Report to the Future Melbourne (Planning) Committee

Agenda item 6.1

Ministerial Planning Referral: TPMR-2010-28/A 63-83 Kings Way and 127-129 Kavanagh Street, Southbank

PLANNING REPORT MINISTERIAL REFERRAL

Figure 7: Comparative Massive (Source: Elenberg Fraser)

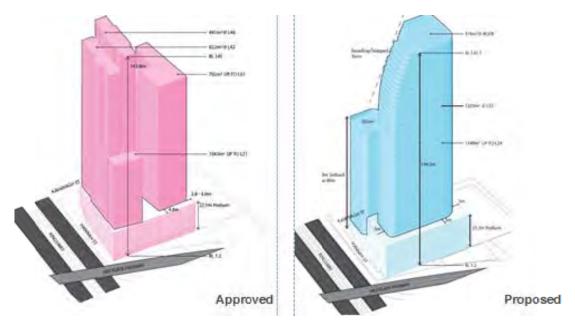
The proposal now responds to its context by holding the corner to Kavanagh Street and Kings Way and utilising the existing heritage building to create a vastly improved lower level streetscape, in particular as seen from Kavanagh Street and Boyd Park (refer to Figure 6 below). There is also now a tower setback to Kings Way and transitionary elements to the tower forms which help to reinforce the prominence of the podium level and allow breathing space to emphasise the complementary and engaging new and old elements. The orientation of the two towers is also now responsive to context by moving the larger tower away from Kavanagh Street and Boyd Park and by breaking up the previous sheer mass of the Kings Way frontage, a more sensitive and prominent vantage point compared to the freeway side. The comparative picture below (Figure 7) visually demonstrates the success of the changes to the scheme.

Figure 9 Comparison of setbacks between the proposed and approved development (Source: Elenberg Fraser)

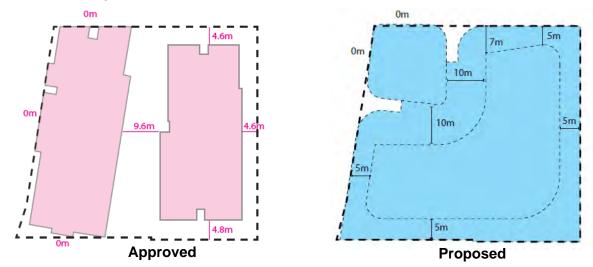
'Whilst the building footprint has been varied; the alignment of the building envelope generally remains in accordance with the approved setbacks and where slight alterations have been made an improved design outcome results. Although not necessarily required, the proposal has been designed to meet the modified setback requirements of DDO10, ensuring that the amended building form reduces the extent of 'non-compliance' from the existing approval.

Building setbacks at the tower level are proposed as follows:

In summary, the proposed setbacks are an improved contextual response compared to the existing, ensuring sufficient visual relief is provided to adjoining sites and when viewed from the public realm, in particular Kavanagh Street and the future Boyd Park.

Figure 10 Comparison of wind conditions between the existing scheme and approved development (Source: Elenberg Fraser)

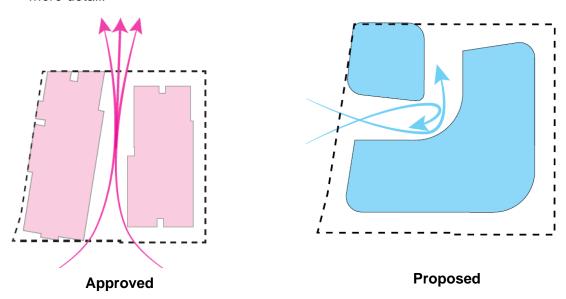
As stated by the applicant, and reinforced in the submitted Mel Consultants report in more detail, on page 25 of the planning report:

'Due to the narrow separation between the towers, wind velocity will increase as it exits the pinch point and possibly cause wind speeds above comfortable walking levels at Boyd Park. In contrast, due to the L-shape of the proposal, southerly winds will be blocked by the proposed building and as a result will not cause an increase in wind velocity to the north at the new proposed Boyd Park.

- d) Any changes required by additional wind testing as required by condition 6.
- e) Any changes required by Waste Management Plan.
- f) Any changes required by the Landscape Plan.
